# 802.3ch Communication link access latency – Table 78-4

July 10, 2019

Jim Graba

# Graphical measurement of Table 78-4 LPI timing parameters

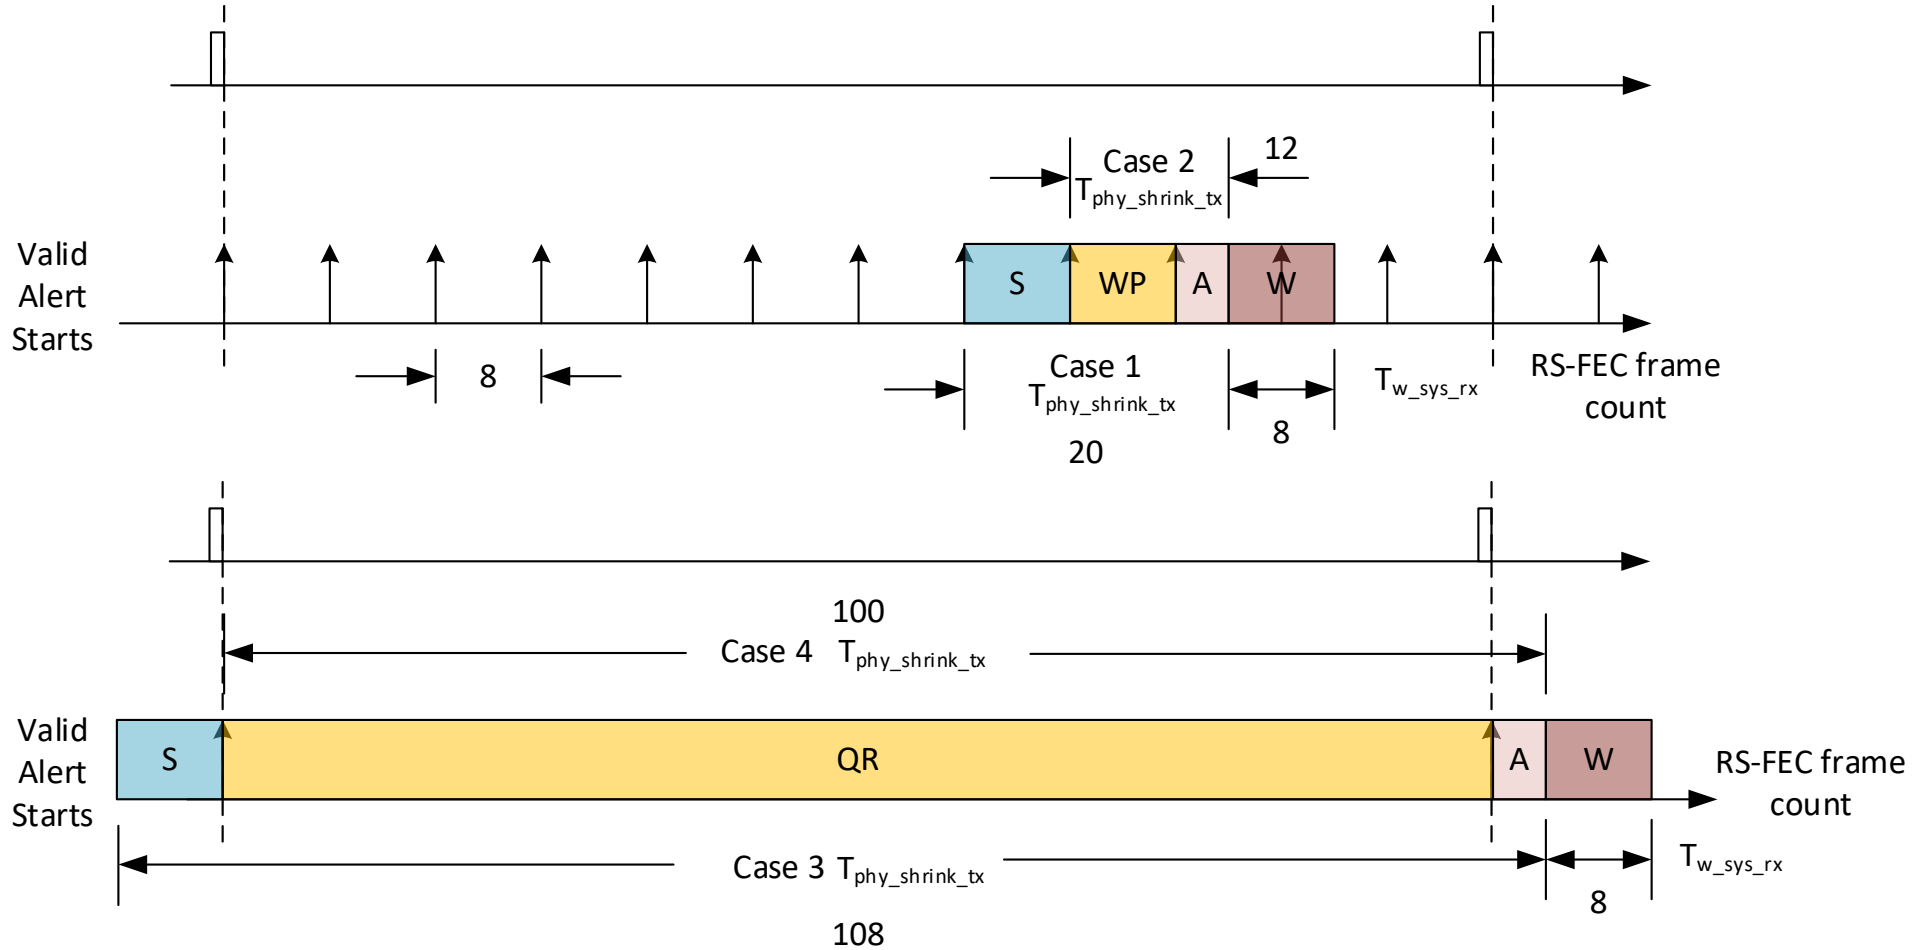
- Use Figures 149-13 and 149-14.
